Tail Lights Brake Lamp Electrical Rework

This procedure is for changing the functionality of the tail lights in the J4500 coaches, such that it abides by the New Jersey Administrative Code Section 16:53-3.30, which requires the stop lights to be “separate and independent” of all other rear lights on the coach.

This rework can be used for J4500 coaches MY2013.and onward

For the *Left-Hand* Tail Lights:

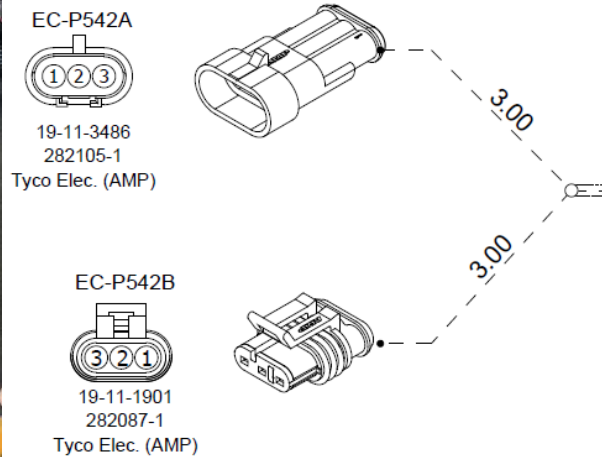
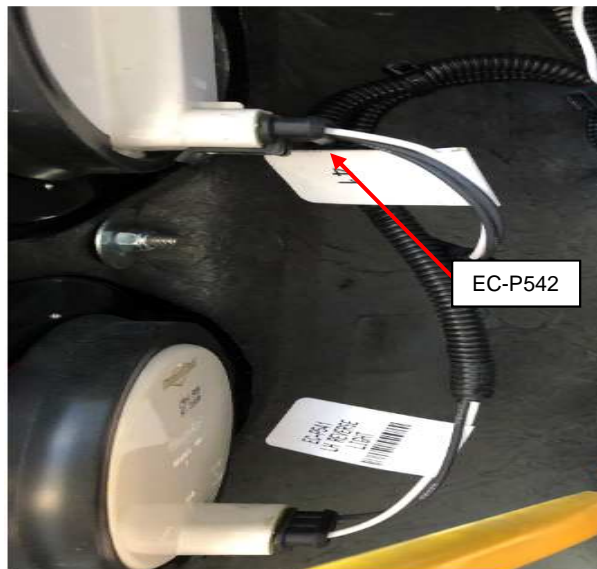
Disconnect the red tail-light connectors from the left-hand lamp assembly.

Connect the existing top harness male connector (EC-P543) to the female connector (EC-P453A) on the jumper harness (MCI P/N: T12-1216).
 Connect the male end of the jumper harness (EC-P453B) to the top tail light.

Run the jumper harness down and connect the existing middle harness male connector (EC-P542) to the female connector (EC-P452A) on the jumper harness.
 Connect the male end of the jumper (EC-P452B) to the middle tail light.

For the *Right-Hand Tail Lights*:

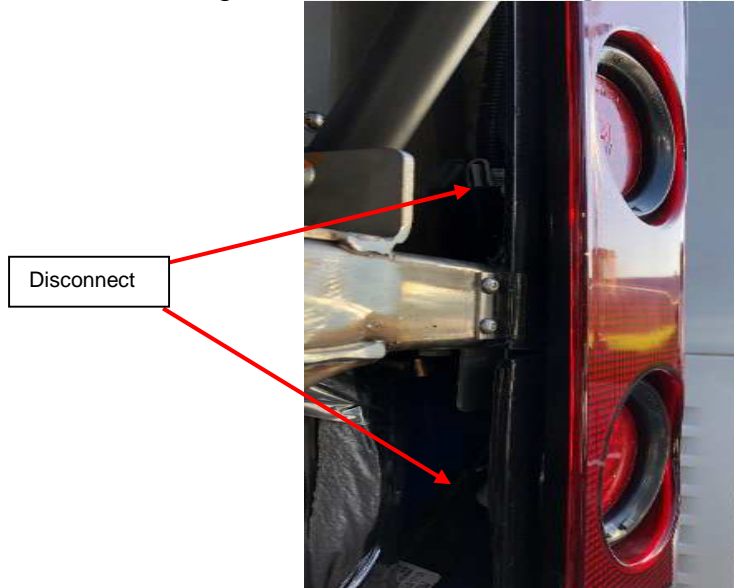
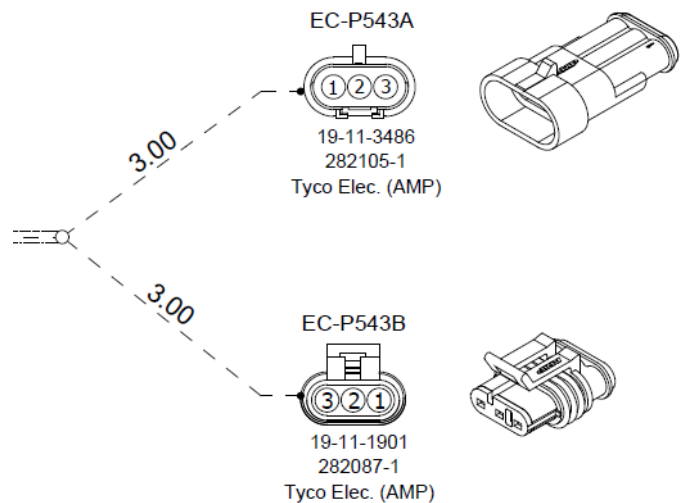
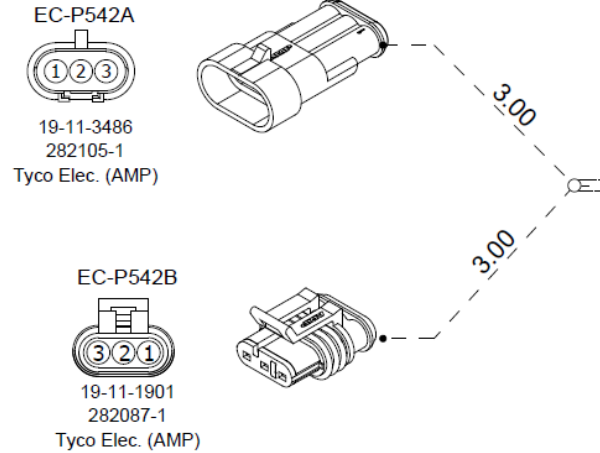
Disconnect the red tail-light connectors from the right-hand lamp assembly.

Connect the existing top harness male connector (EC-P540) to the female connector (EC-P543A) on the second jumper harness (P/N: T12-1216).

Connect the male end of the jumper harness (EC-P543B) to the top tail light.

Run the jumper harness down and connect the existing middle harness male connector (EC-P539) to the female connector (EC-P542A) on the same jumper harness.

Connect the male end of the jumper (EC-P542B) to the middle tail light.
